SERVICE BULLETIN

AmSafe Seatbelt Airbag System
Extended Service/Storage Life for Inflator
Assemblies

SB507592-401-25-01

Figure 1. Example "DATE OF MFG" Label

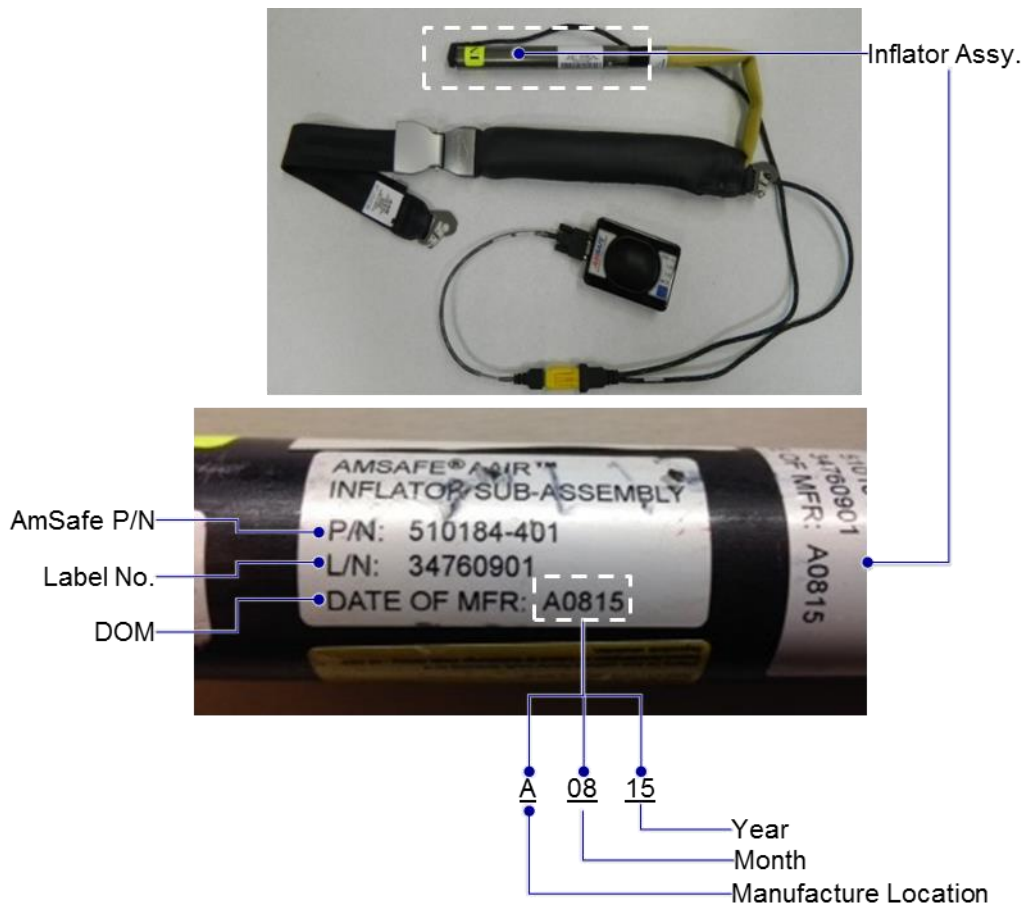
4. There are two types of labels on inflator assemblies.
 - a. Labels with "DATE OF MFR:" (Figure 1): Add 12 years to the month and year and obtain the service/storage life of the inflator assembly.
